NORTH FALLS

Offshore Wind Farm

Outline Construction Traffic Management Plan (Tracked)

Document Reference: 7.16
Volume: 7
Date: April~~March~~ 2025
Revision: 32

Drawing 104560-MMD-00-XX-DR-CE-1070_Rev01

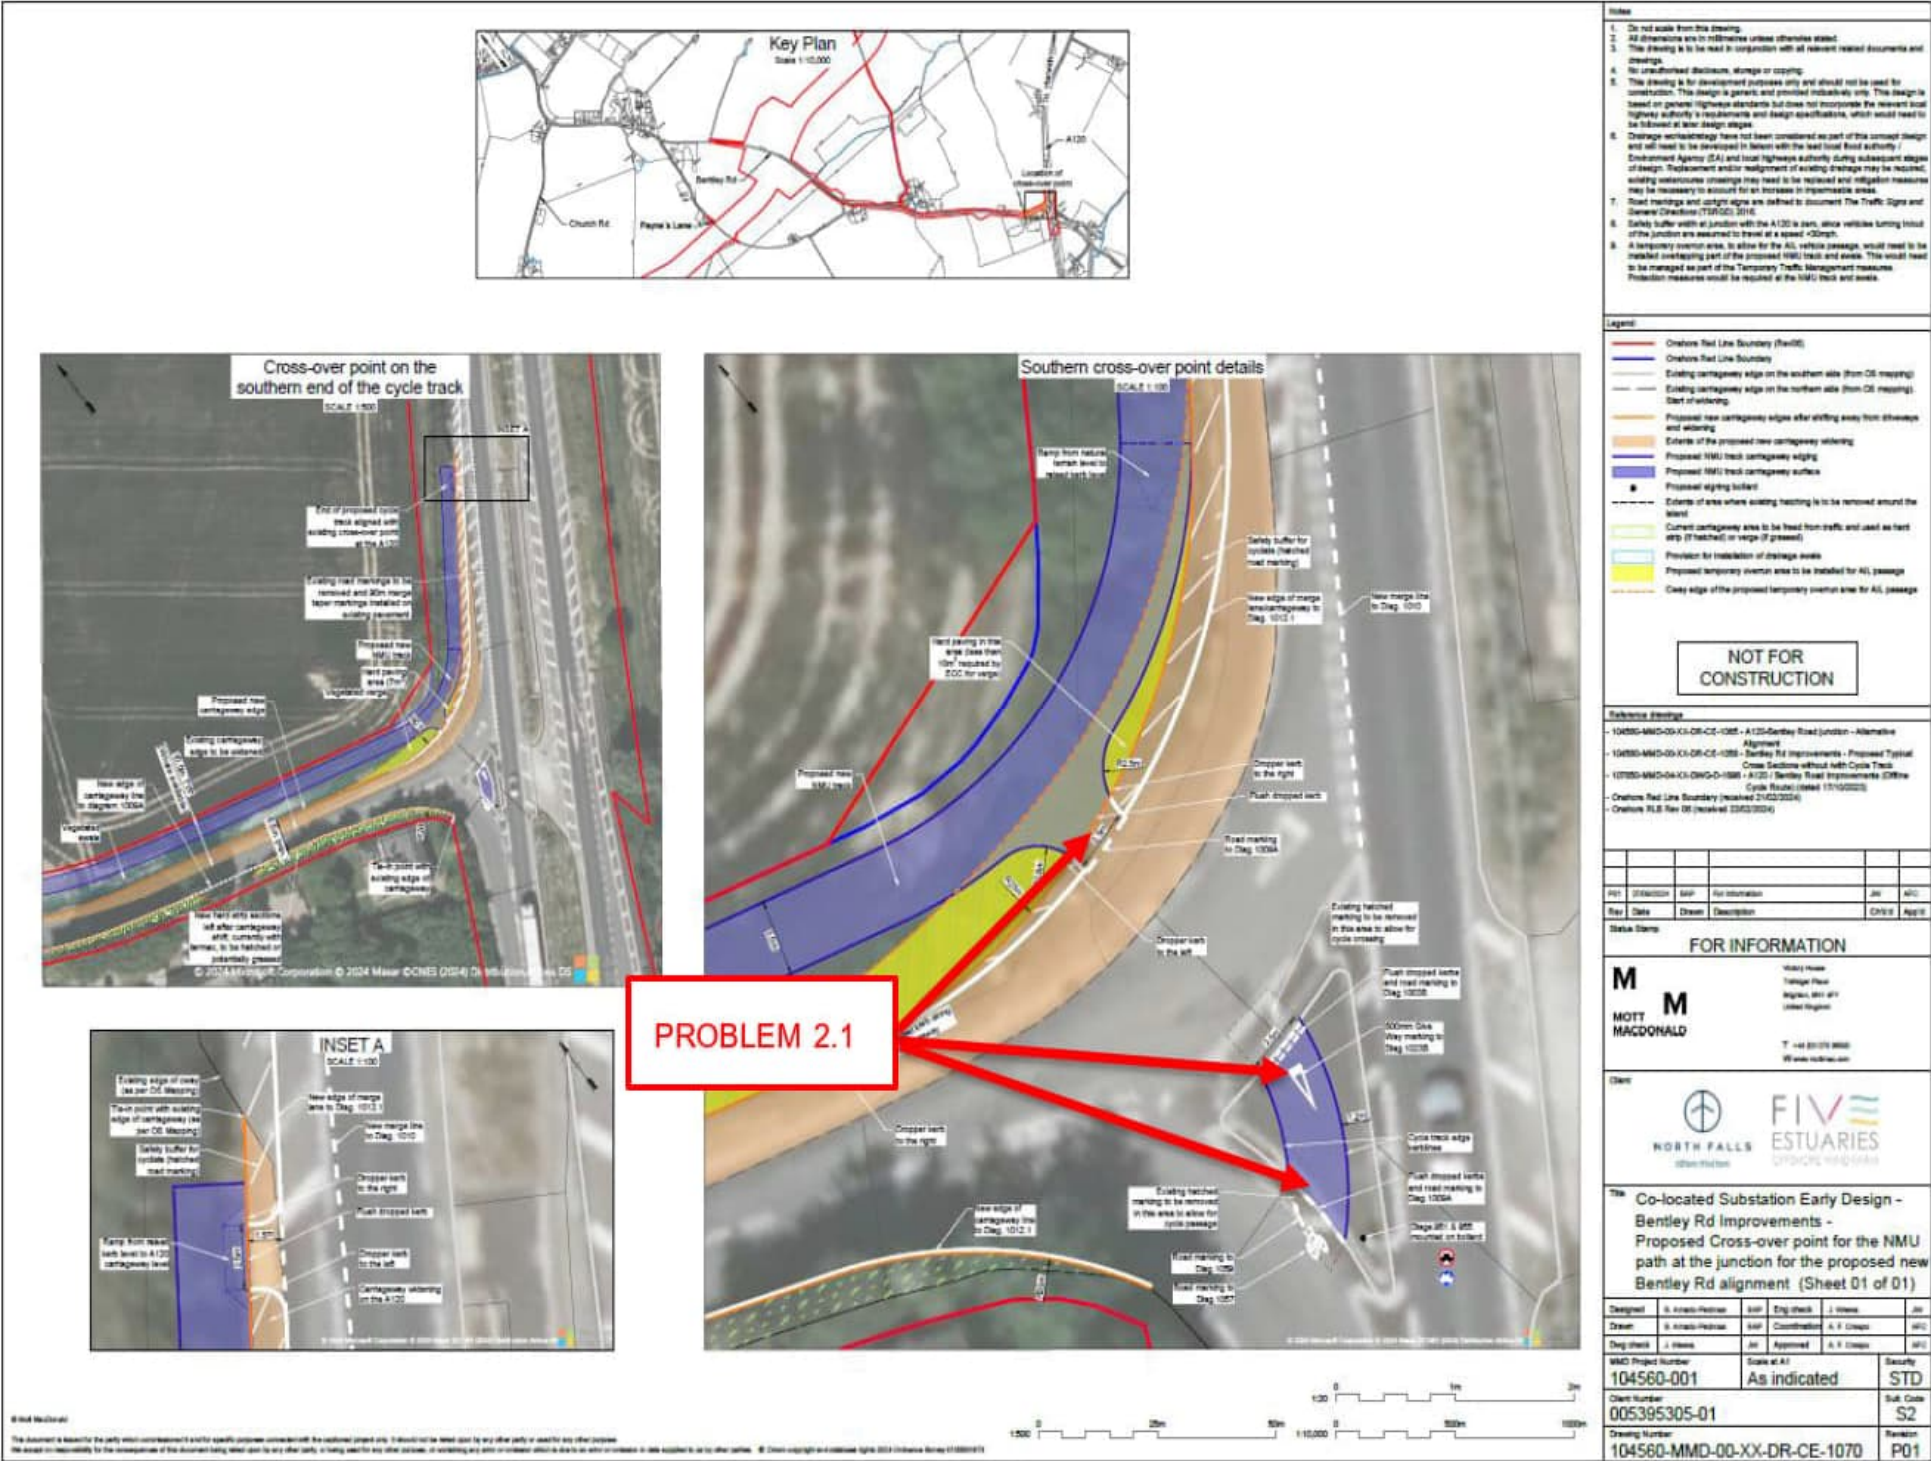
Drawing 104560-MMD-00-XX-DR-CE-1070_Rev01						
2.1	Location: A120/Bentley Rd Junction. Summary: Lack of hazard warning tactile paving provided at dropped kerbs leading to the NMU route may lead to collisions between NMUs and vehicular traffic. Design drawings show an extension of the NMU route adjacent to the A120. An existing splitter island will be amended with dropped kerbs and road markings to allow NMU users to leave the A120 Northwest bound. This design is not shown complete with hazard warning tactile paving that would alert NMUs particularly those with visual impairments that they are about to enter the vehicular carriageway. This arrangement may in turn lead to collisions between NMUs and vehicular traffic.	It is recommended that any access points to the vehicular carriageway are provided with the appropriate tactile paving installations.	● RSA problem acknowledged but recommendation partially dismissed due to the crossover movement only being allowed to northbound cycles and cycle access points to/from the carriageway not requiring the installation of tactile pavement. ● To provide greater clarity to the crossing movements allowed at this crossover point and to improve safety, both for pedestrians and cycles, a segregated shared use section of the NMU track is to be added along the area of concern to direct pedestrians away from the crossover. Tactile pavement is to be installed at the start and end of this segregated shared use section of the NMU track, in line with the Department for Transport document: <i>Guidance on the Use of Tactile Paving Surfaces</i>, Section 5. Ladder tactile pavement shall be installed at the start/end of the pedestrian way within the NMU track for a depth of 2.4m each, and width of 1.5m (width of the pedestrian way). Tramline tactile pavement shall be installed at the start/end of the cycle way within the NMU track for a depth of 2.4m each, and width of 2m (width of the cycle way). The ladder and tramline tactile pavement will assist vision impaired people. Diagrams 956 & 957 mounted on bollards and installed at the start/end of the segregated shared use section of the NMU track would also assist all other users. The installation of Diagrams 956 & 957 is a recommendation within <i>Guidance on the Use of Tactile Paving Surfaces</i>, Section 5 and LTN 1/20 paragraph 9.4.3, however their installation shall be discussed with the ECC LHA to avoid sign clutter. ● The segregated shared use NMU track will direct pedestrians away from the crossover point at the junction, greatly reducing the risk of pedestrians trying to cross. ● It is also proposed that the carriageway at the cycle area of the segregated shared use NMU track is surfaced in a different colour than the rest of the NMU track, to make it more conspicuous to all users. ● Additionally, the corner radii at the NMU track leg leading to the trafficked carriageway have been reduced to R=1m and the leg width, to 2.5m, except at the corner radii, to reduce comfort at making the turn. Edge of lane road markings have been proposed at the intersection of this leg with the NMU mainline cycle track and directional arrow road markings to emphasize the one-way character of this cycle track leg. ● This matter will be appraised further, in conjunction with the Local Highways Authority, as an integral part of the detailed design process, when bespoke signing and road marking drawings and specifications are to be agreed and produced for the preferred solution.	To be populated by the Audit Team	To be populated by the Client / Project Sponsor	This matter will be appraised further, in conjunction with the Local Highways Authority, as an integral part of the detailed design process, when bespoke signing and road marking drawings and specifications are to be produced for the agreed preferred solution. All measures to increase safety, described at the Design Organisation Response column, to be added to drawing 104560-MMD-00-XX-DR-CE-1070_Rev02.

Drawing 104560-MMD-00-XX-DR-CE-1066_Rev02						
2.2	Location: A120/Bentley Rd Junction. Summary: Overrun of Exceptional 74.720m HGV into NMU corridor. Design drawings show swept path analysis of a multi axle drawbar HGV entering Bentley Road from the A120. The analysis drawing indicates that the body of this exceptional HGV will over sail the new NMU route as the vehicle turns from the A120 onto Bentley Road. This	It is recommended that banks persons are used where HGVs are required to make turns along the route to ensure that pedestrians and vulnerable road users are separated from large vehicle turning movements.	● RSA problem acknowledged and recommendation agreed. ● The use of banks persons is implicit within the Temporary Traffic Management measures to be agreed with the Local Highways Authority. These TTM measures shall be detailed at a later stage of the project. ● A note specifying the use of banks persons shall be added to drawing 104560-MMD-00-XX-DR-CE-1066_Rev03 for clarity.	To be populated by the Audit Team	To be populated by the Client / Project Sponsor	A note specifying the use of banks persons shall be added to drawing 104560-MMD-00-XX-DR-CE-1066_Rev03 for clarity. TTM measures shall be detailed and agreed with the LHA at a later stage of the project.
